Office Action Summary	Application No. 10/508,772	Applicant(s) GRIESE, ROLAND	
	Examiner Jeffrey A. Shapiro	Art Unit 3653

DETAILED ACTION

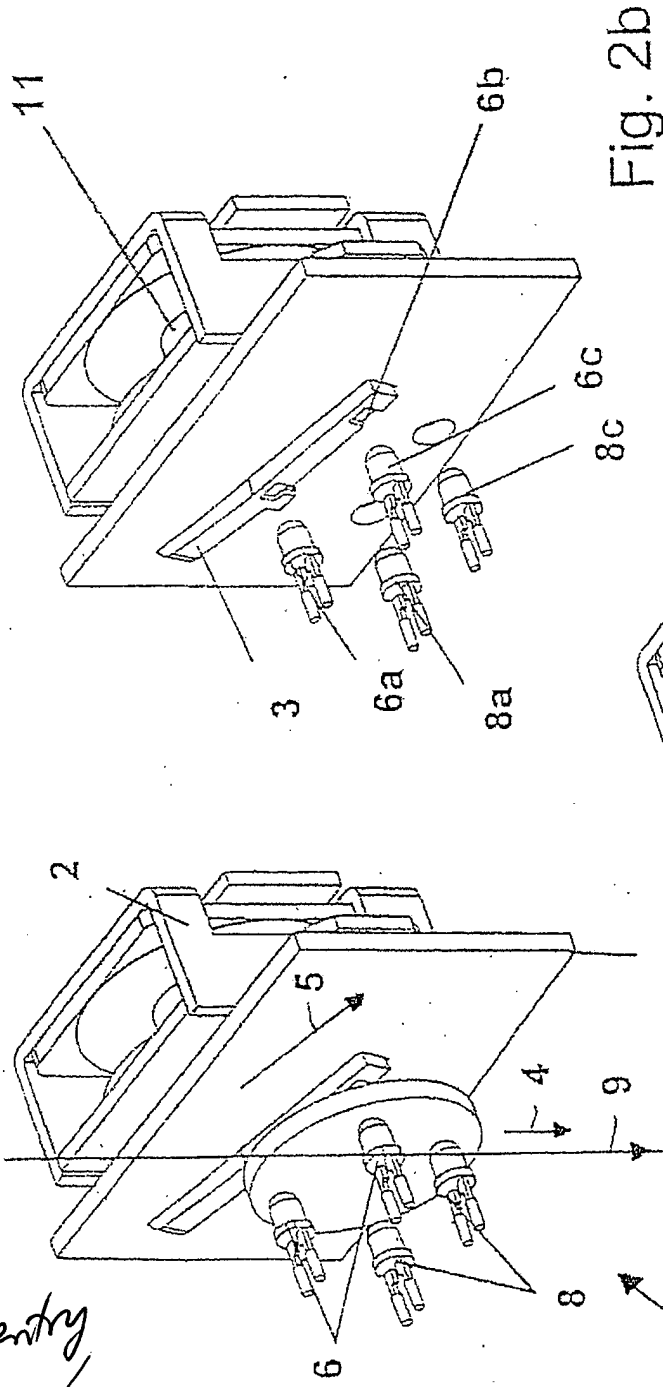
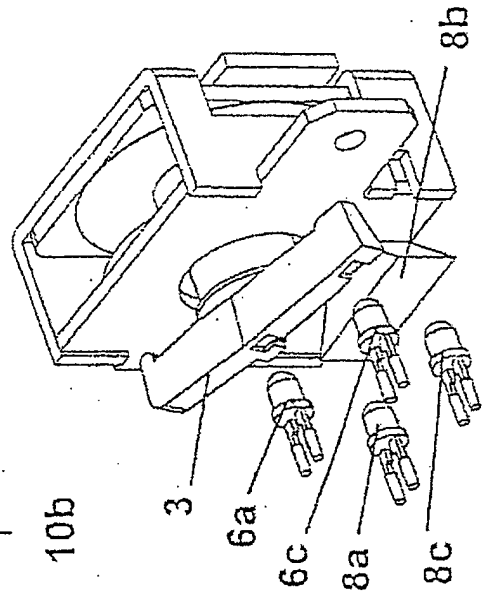
ok for entry
 JAL
 12/8/07
